OF A REGULAR MEETING
OF THE
CITY OF COACHELLA
PLANNING COMMISSION

February 16, 2022
6:00 PM

SUBJECT: Woodspur Farms Photovoltaic Project - A request to consider an appeal of conditions of approval contained in the Architecture Review (AR) 21-10 (Admin) for a solar farm project located 52200 Industrial Way. Applicant, William Hsien

SITE PLAN

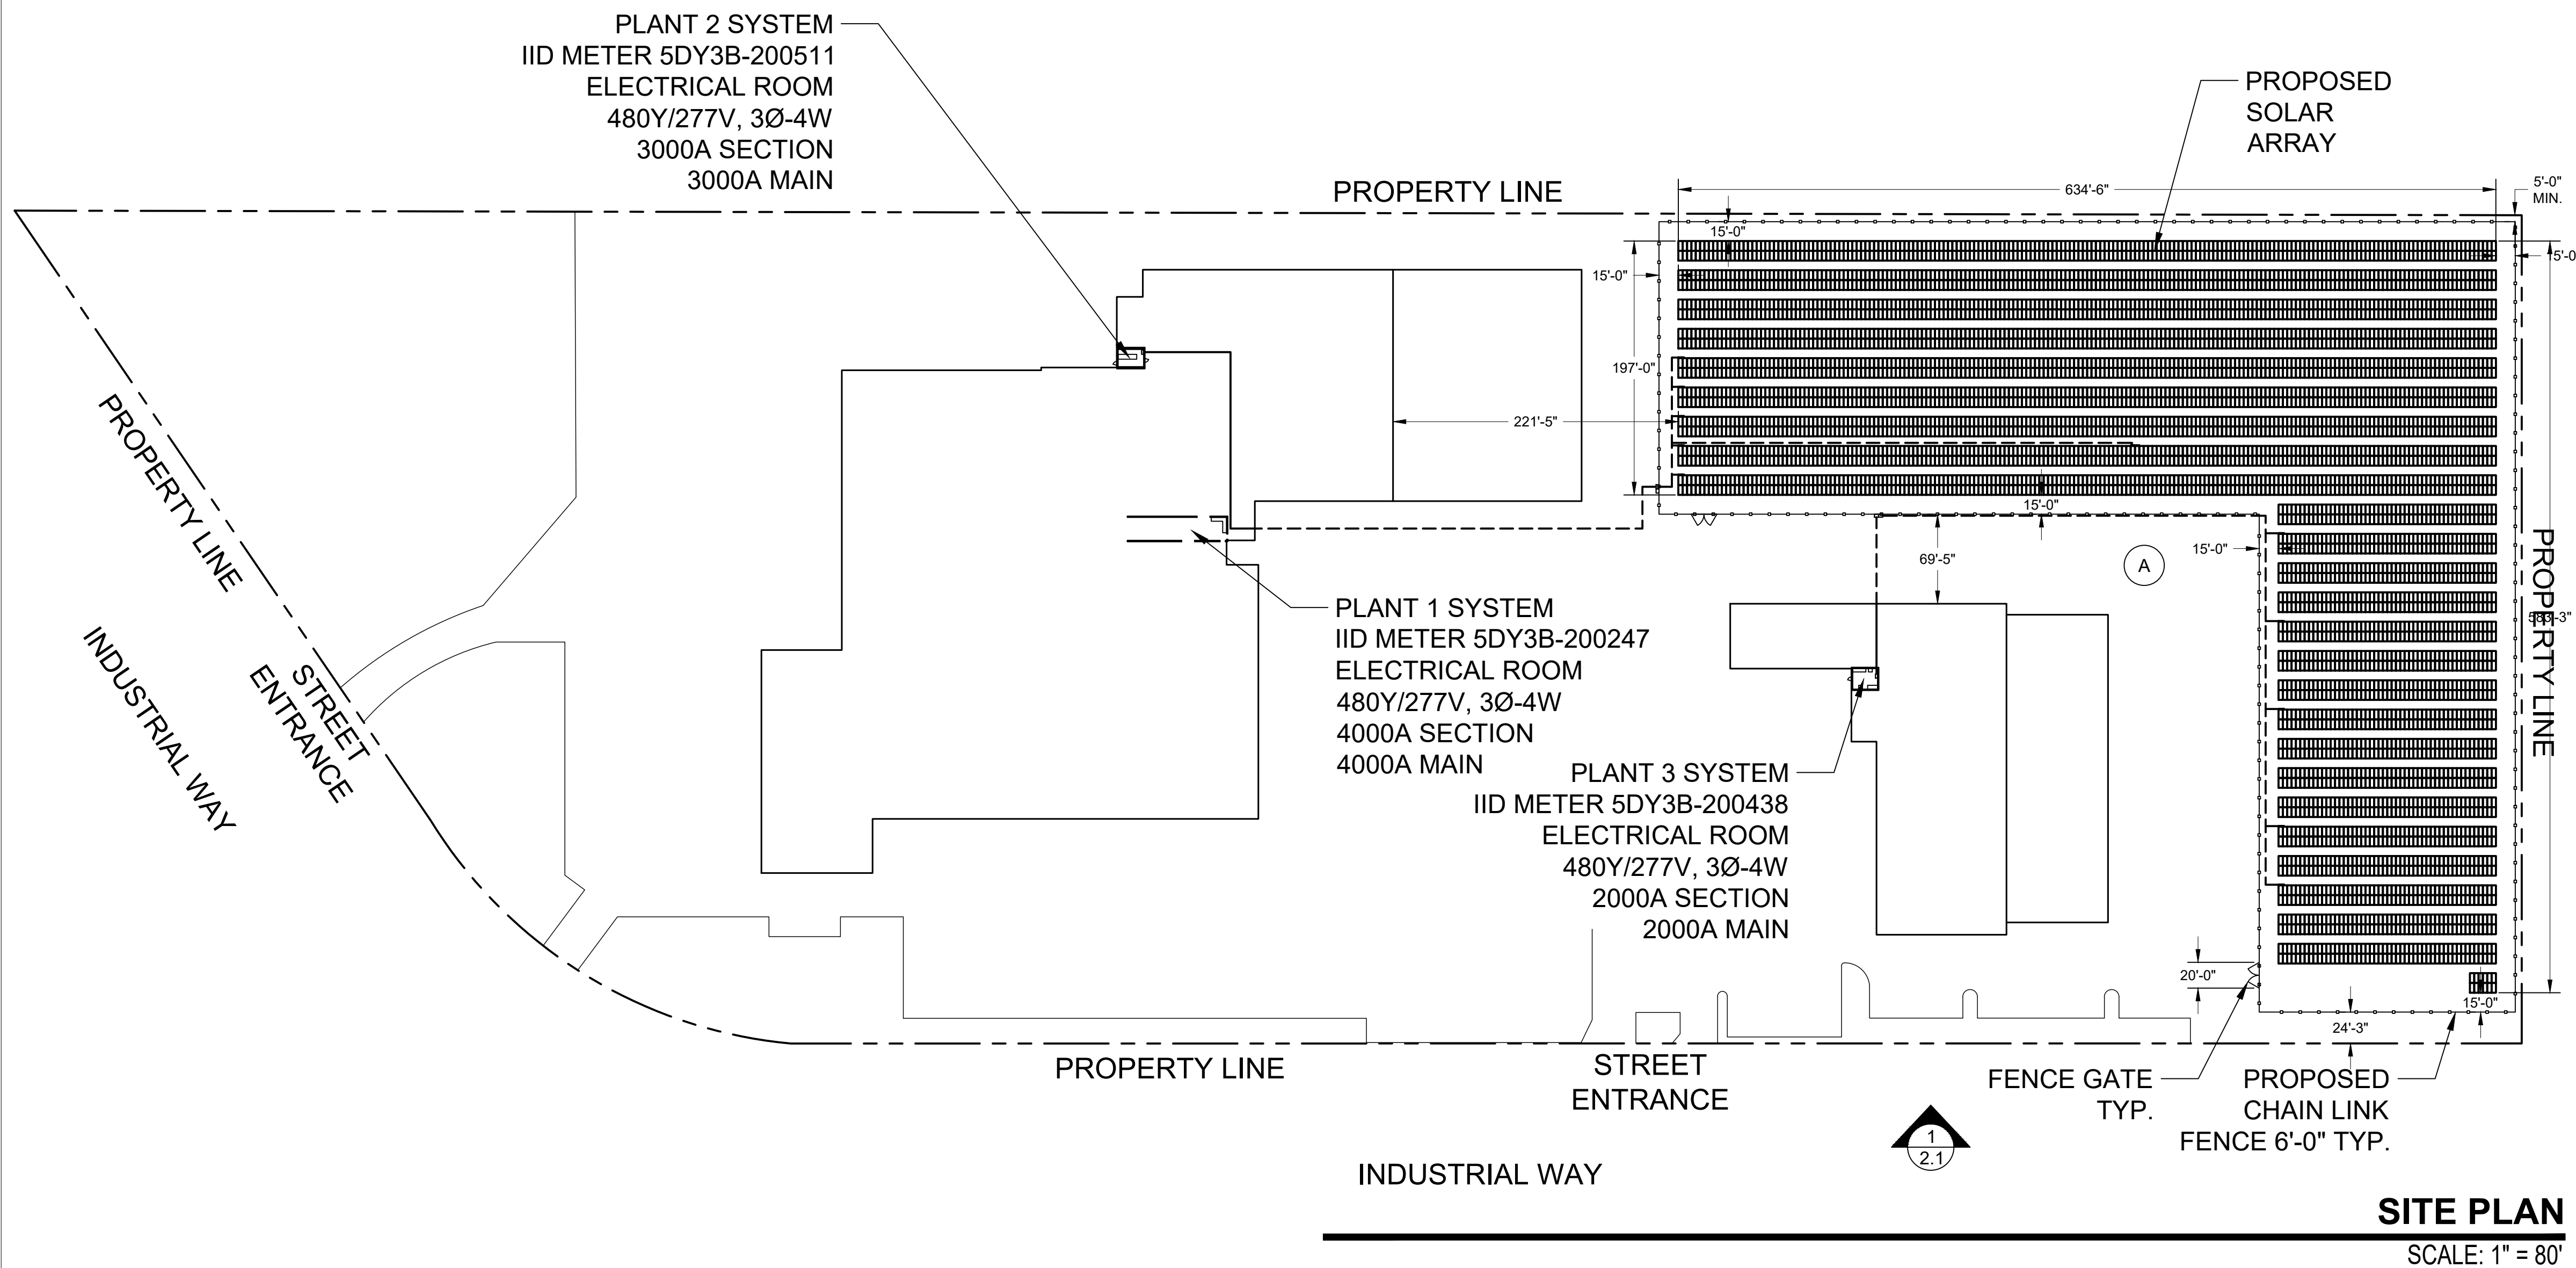
1. The scope of work on the plan states roof mounted photovoltaic modules but the City of Coachella’s project summary describes a proposed ground mounted solar farm. Correct the plan and clarify the project description.

2. Show the fire apparatus access road on the site plan. The fire access road shall extend to within 300 feet of all portions of the facility - as measured from the access road to all portions of the facility on an approved walkway through and between the length of solar arrays. The access road shall be a minimum width of 20 feet, have a minimum outside turning radius of 38 feet, and be capable of supporting the load of fire apparatus (50,000 lbs.) under all weather conditions. Access gate openings for vehicles shall be a minimum of 14 feet wide and 4 feet wide for pedestrian access.
